## DEVELOPMENT APPLICATION ASSESSMENT REPORT

Application Number:	DA2020/1425
---------------------	-------------

Responsible Officer:	Rebecca Englund
Land to be developed (Address):	Lot C DP 39108, 1 Kenneth Road MANLY NSW 2095 Lot 3 DP 975160, 265 Condamine Street MANLY VALE NSW 2093
Proposed Development:	Demolition works and construction of a shop top housing development
Zoning:	Warringah LEP2011 - Land zoned B2 Local Centre
Development Permissible:	Yes
Existing Use Rights:	No
Consent Authority:	Northern Beaches Council
Delegation Level:	NBLPP
Land and Environment Court Action:	No
Owner:	Co-Ordinated Projects Pty Limited
Applicant:	Co-Ordinated Projects Pty Limited

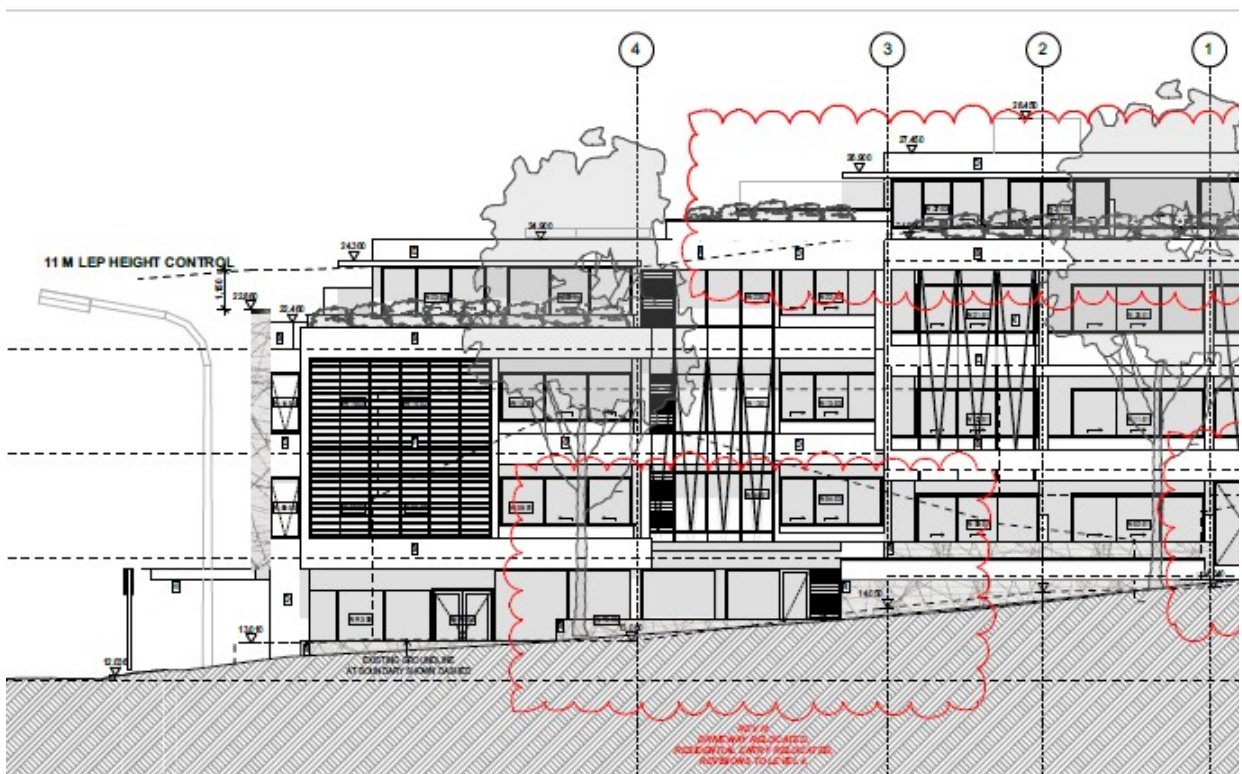
- The entire roof form and upper-most portion of the building fronting Condamine Street protrudes beyond the height plane, with a maximum non-compliance of 2.8m at the south-east corner (where the building is also non-compliant with both the minimum front and side setbacks applicable).

- The proposed roof terrace (and access thereto) protrudes above the height plane, with a maximum height breach of 4.3m at the south-western lift-core. The non-compliance is not limited to the upper roof terrace, noting that vast majority of the roof of the level below also protrudes above the roof plane, with a maximum non-compliance of 2.3m at the south-eastern corner.

- The entire roof form and upper-most portion of the building fronting Kenneth Road protrudes above the height plane, with a maximum non-compliance of 4.1m at the south-west corner. The height non-compliance is not limited to the upper floor, with portions of the roof of Level 2 also protruding above the height plane.

The extent of non-compliance is demonstrated on the architectural drawings, with the 11m height plane shown on each elevation and section.
